LUXURY HADDAD APARTMENTS 2324 JOHNSON STREET TAC #18-DP-33

TECHNICAL ADVISORY COMMITTEE REPORT

18-DP-33

Site Plan Review for a 12 unit residential development (Haddad Luxury Apartments).

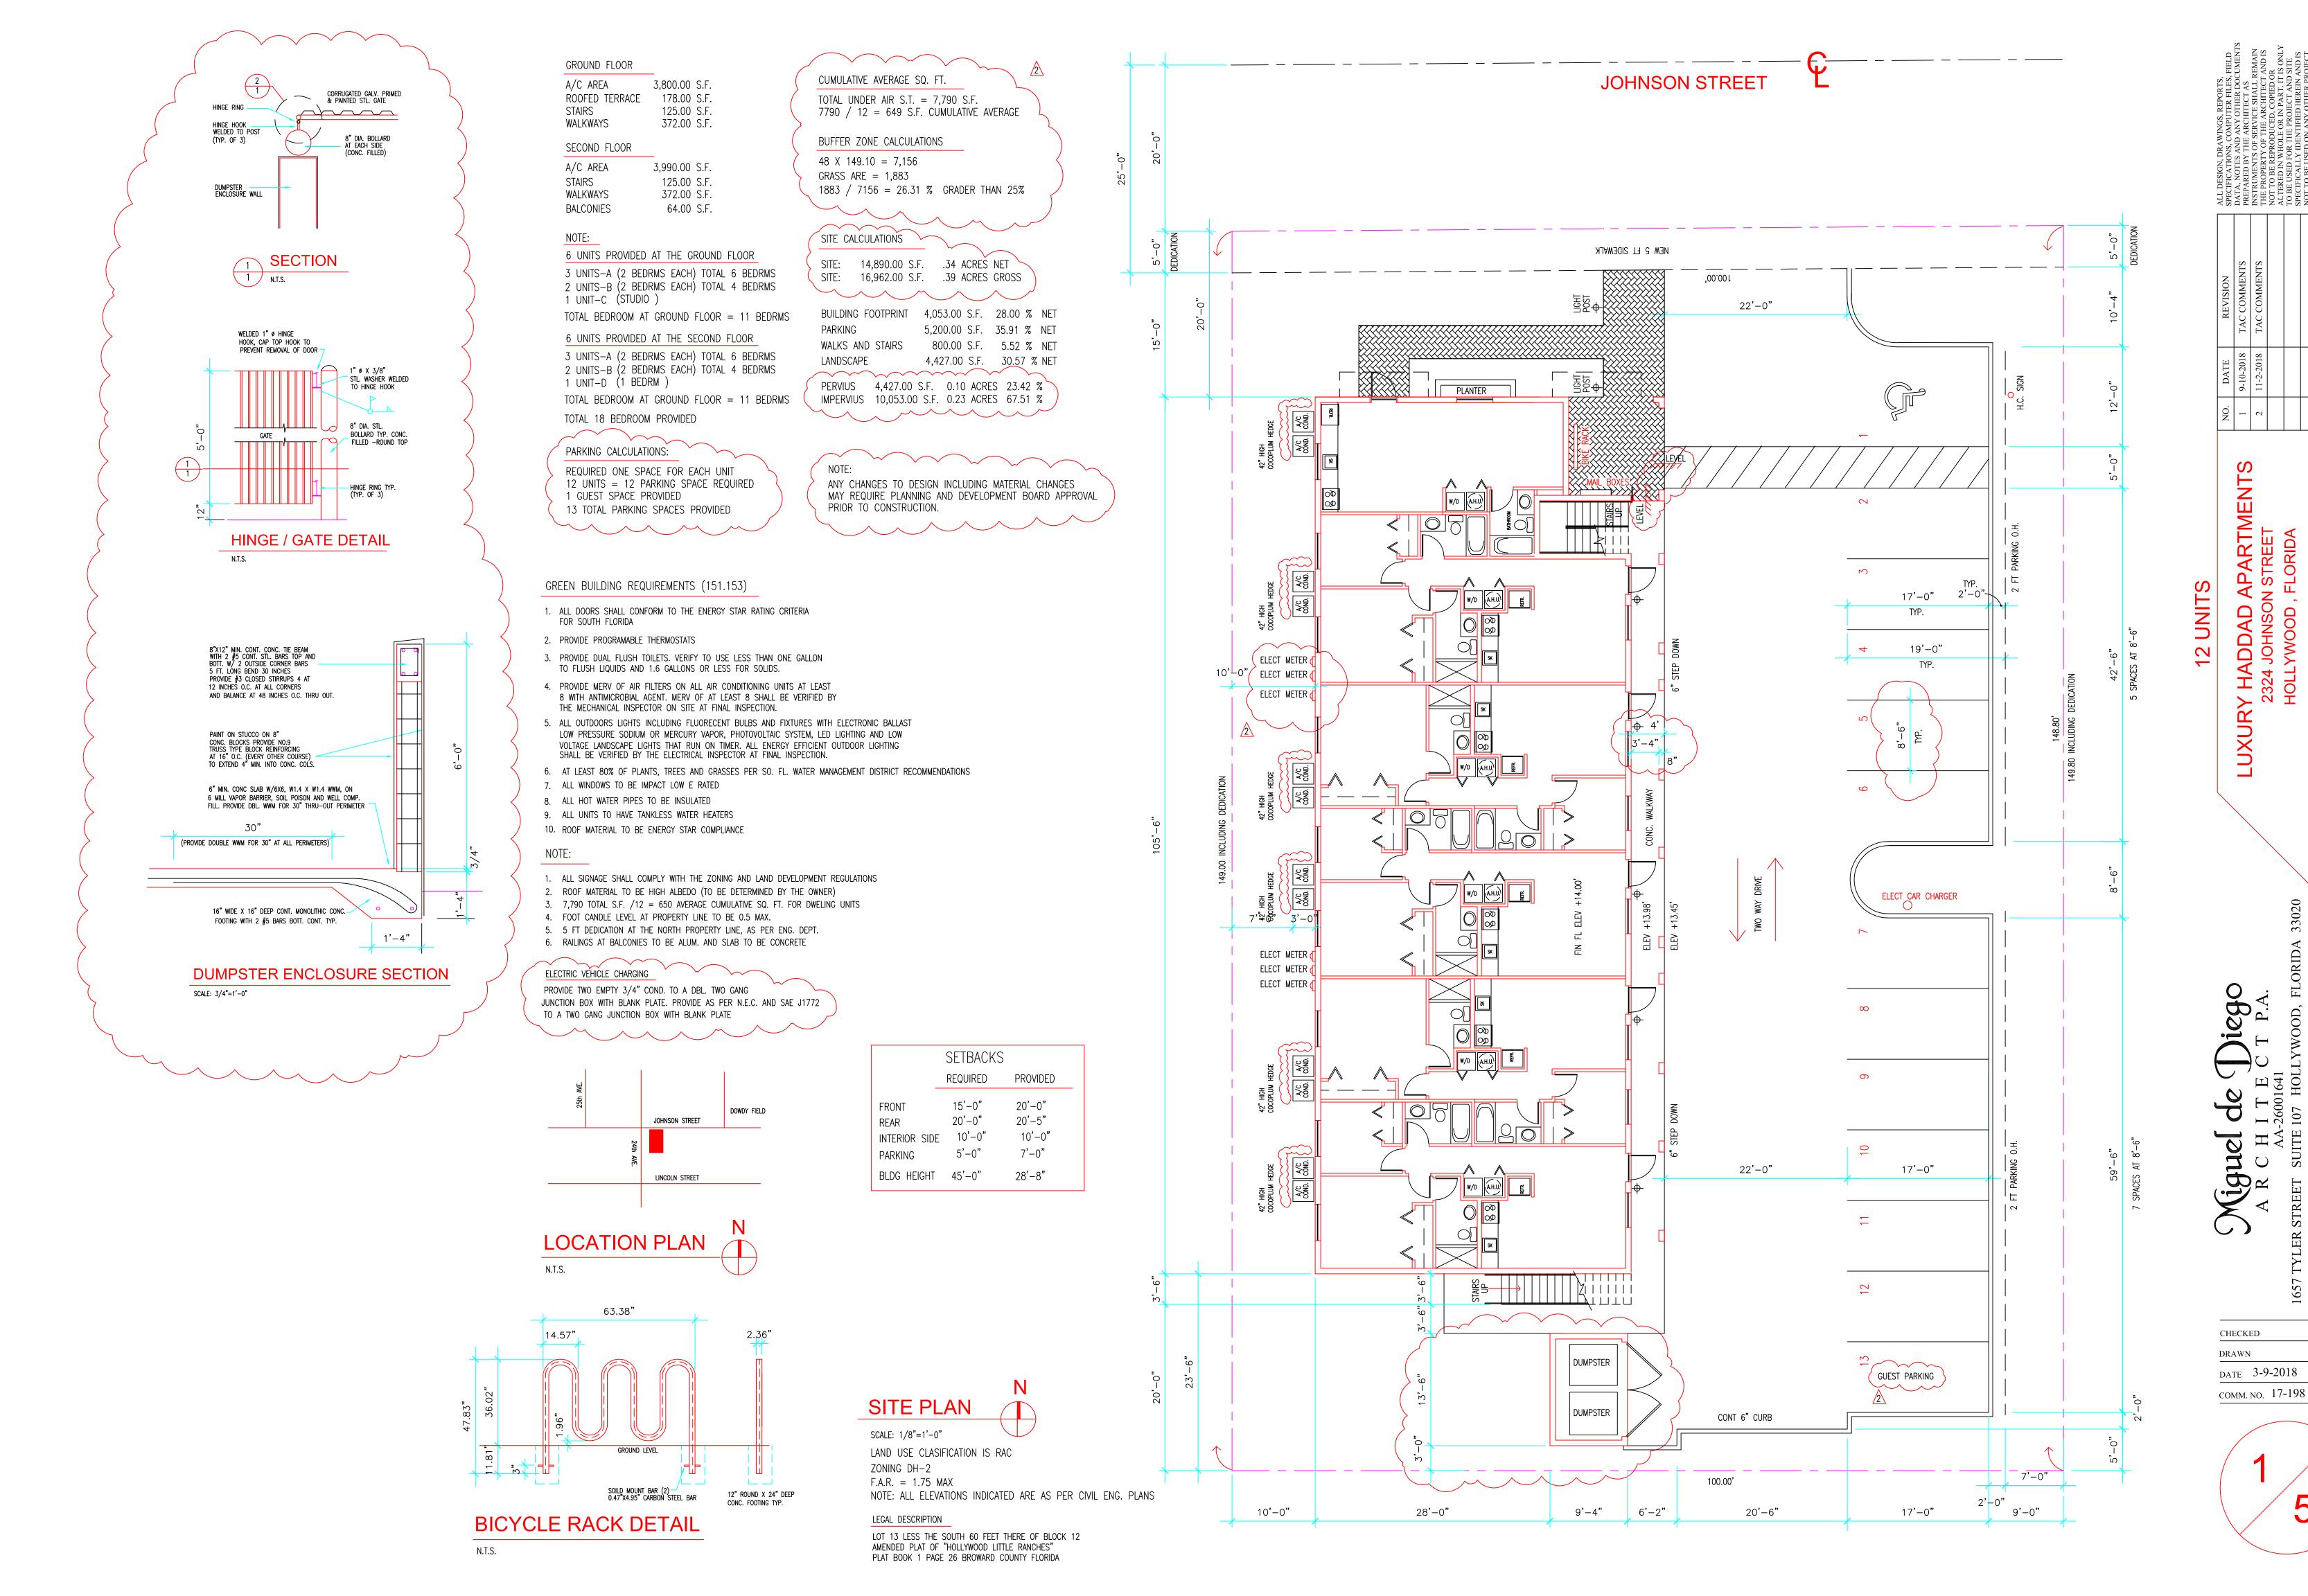
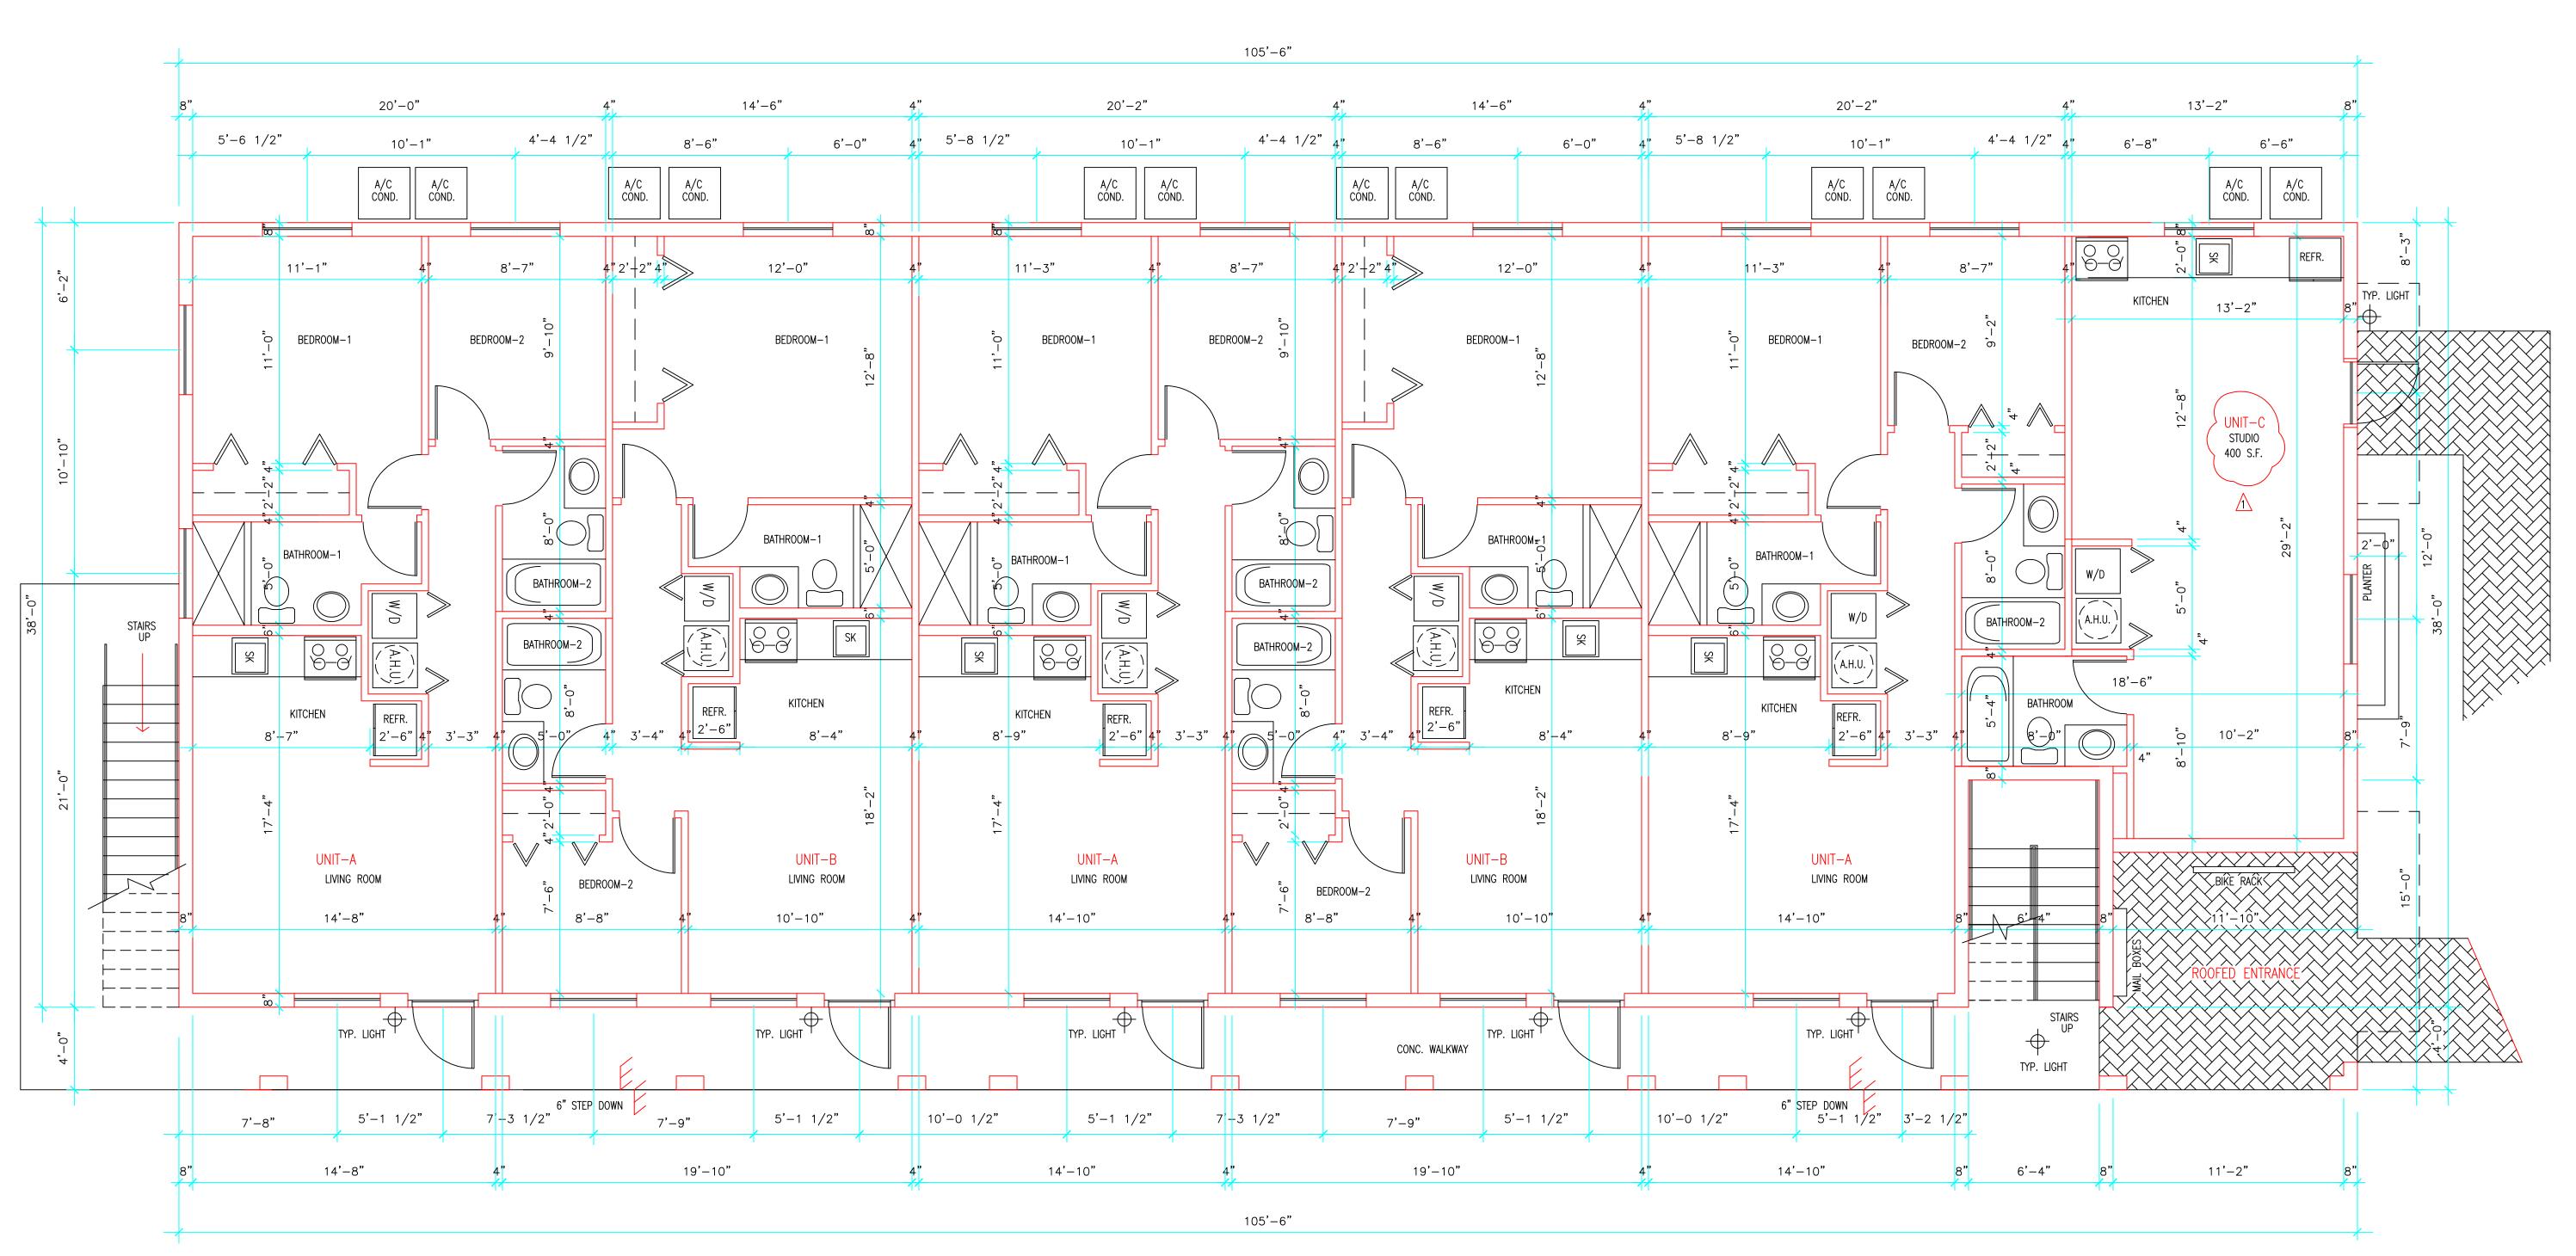
a. Provided Survey is dated prior to O&E Report. Survey shall be based on the current title work (O&E), dated within 30 days of submittal. Such date shall be noted on the survey document. Second request.

- 1-A) See revised index for removed photometric drawings.
 - B) See revised index sheet for location plan.
- 2-See revised index sheet for meeting dates.
- 3-Ok
- 4-See enclosed alta survey.
- 5-A) See revised sheet-1 for net & gross acres.
 - B) See sheet-1 for parking calculations.
 - C) See sheet-1 for previous
 - D) See sheet-1 for cumulative average s.f.
- 6-See sheet-1 for walkway dimensions.
- 7-See sheet-1 for level indication at walkway.
- 8-See revised north arrow designation.
- 9-Ok
- 10-there are no walls, fences or gates.
- 11-Ok
- 12-Ok
- 13-See sheet-1 for acknowledgement note.
- 14-See sheet-1 (site plan for location of utilities)

GROUND FLOOR PLAN

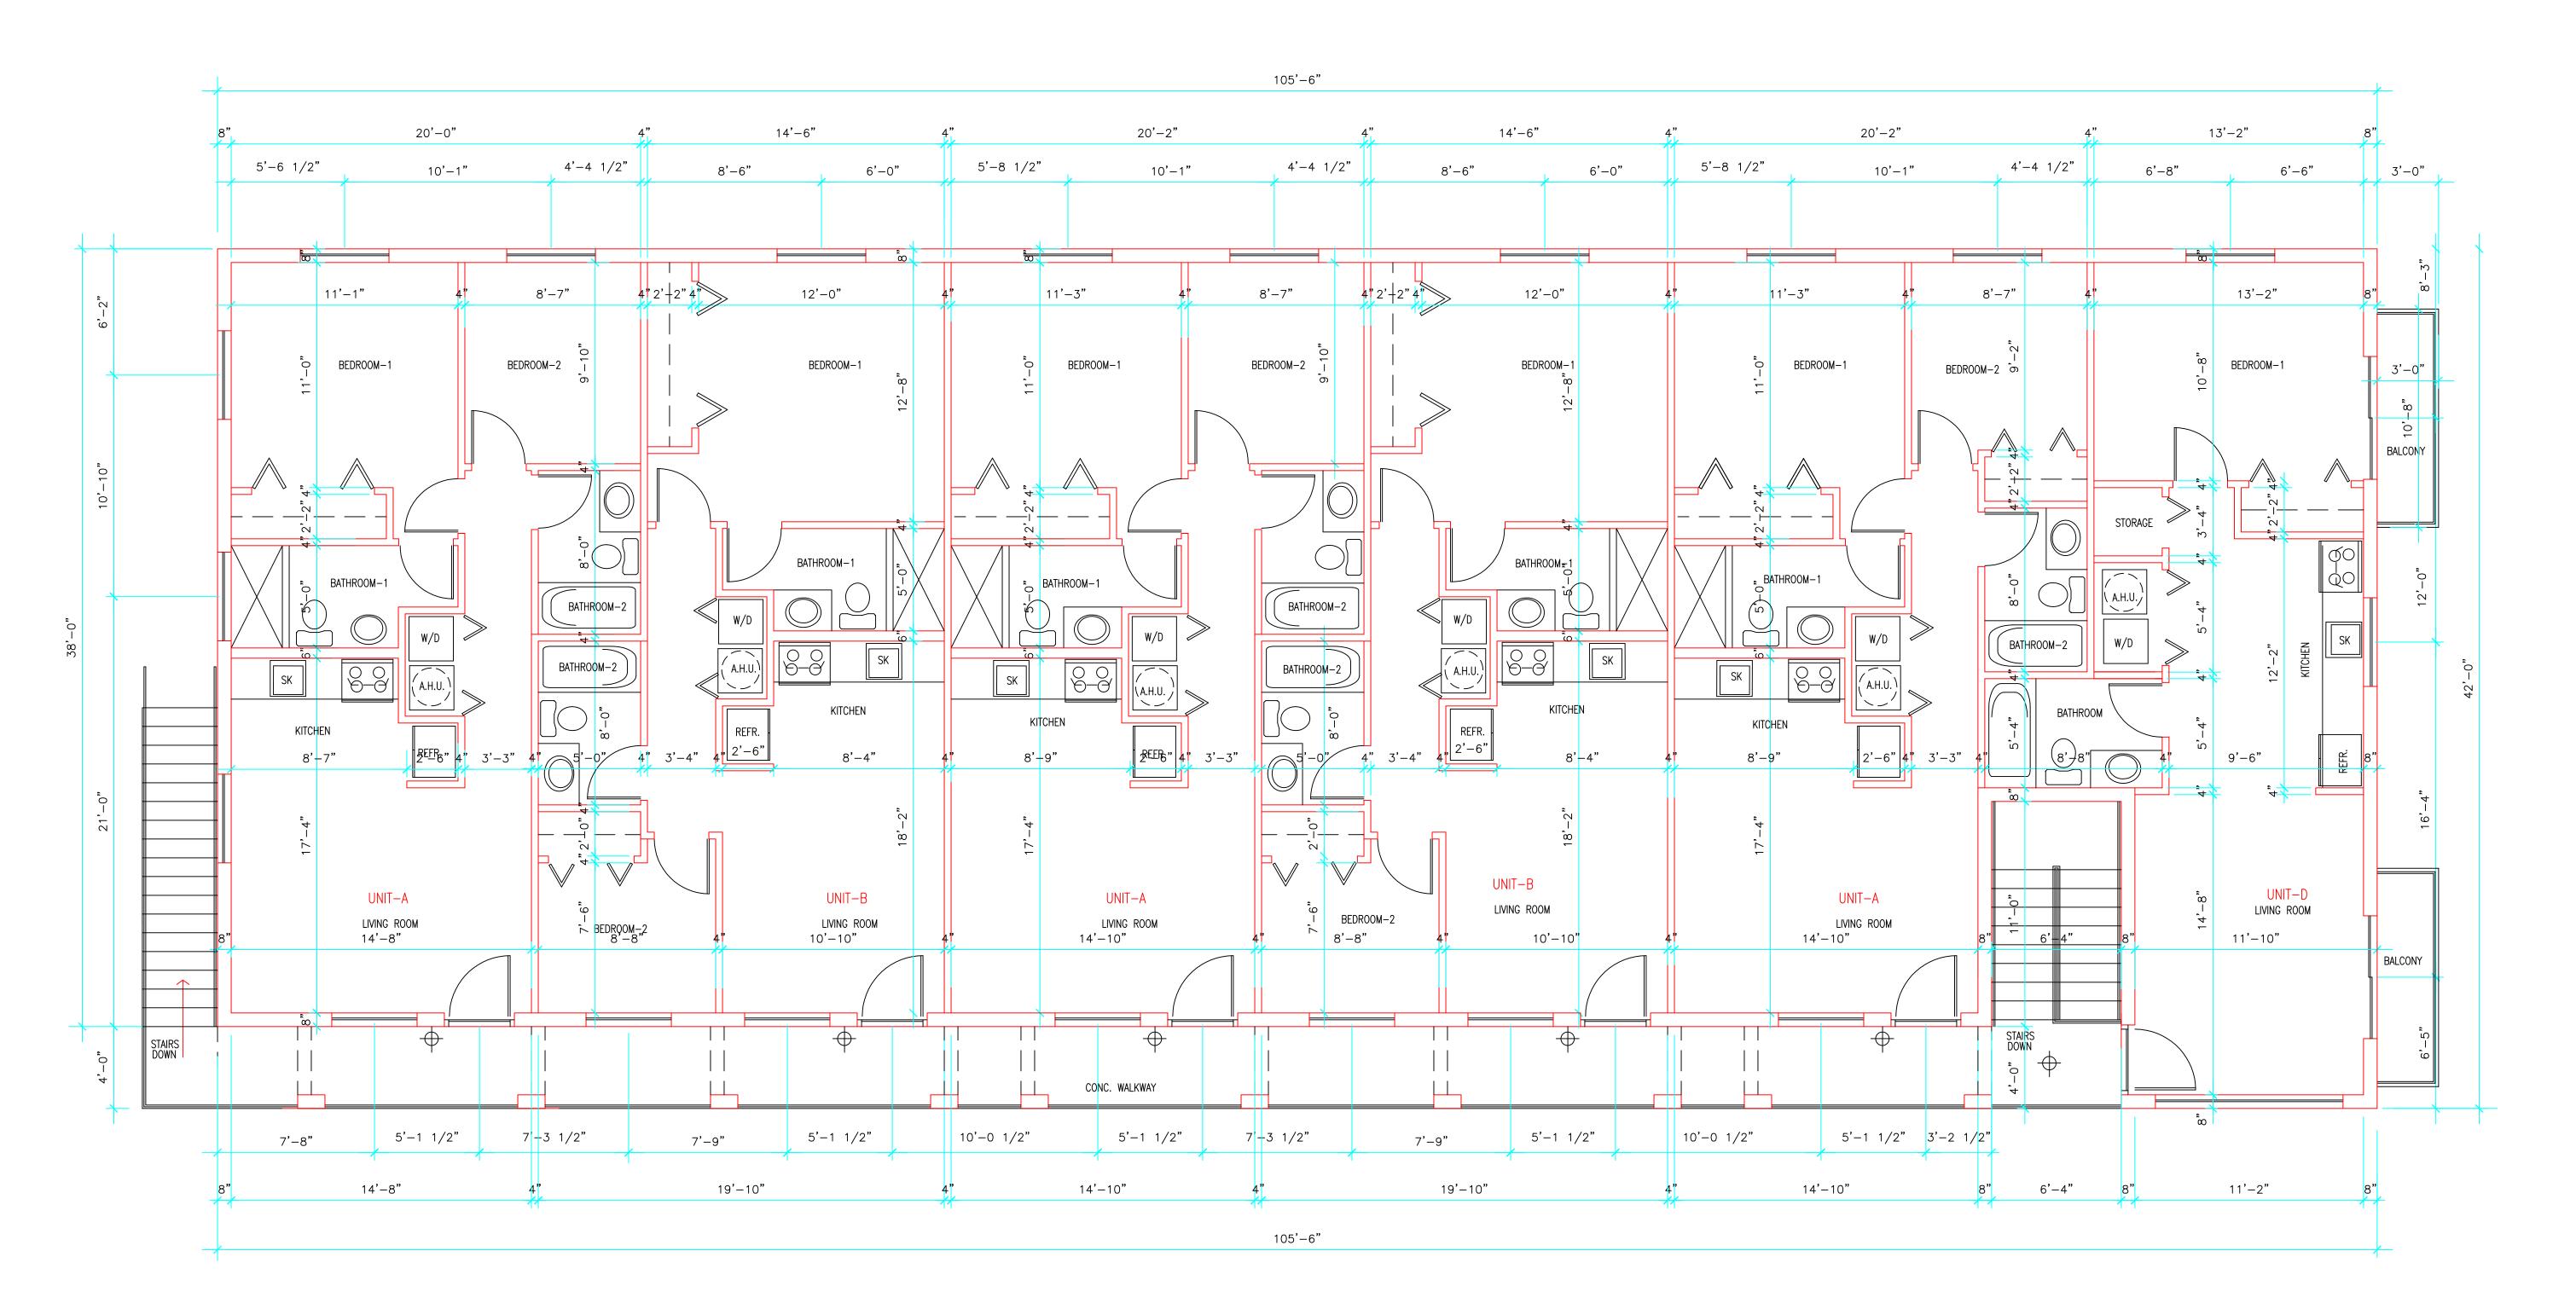
2. Doors must swing inside on 2 nd floor, or provide alcove, Cannot hinder walkway to stairs with outward swinging doors.
K	Janet A. Washburn, Fire Marshal/Division Chief (Iwashburn@hollywoodfl.org) 954-921-3554

- 2-Unit "C" will be for the building manager, he will be responsible for building Maintenance.
- D) No signage on this project.
- E) Photometrics on cover sheet has been removed.
- F) 1-Seesheet-1 for green building requirements.
- G) 1-See site plan for dimension.
 - 2-See site plan for drive isle dimension.
 - 3-Drive isle are 22 feet.
 - 4-Ok
 - 5-See landscape plan.
 - 6-See civil plans.
 - 7-See civil plans.
 - 8-Ok
 - 9-Ok
 - 10-Ok
 - 11-Ok
 - 12-Ok
 - 13-Ok
 - 14-See revised site plan for dumpster gate opening & curbing.
- J) Building:
 - 1-Smallest bedroom is 8'-7" \times 9'-2" = 78.5 s.f.
 - 2-See revised second floor for exterior doors swinging in.
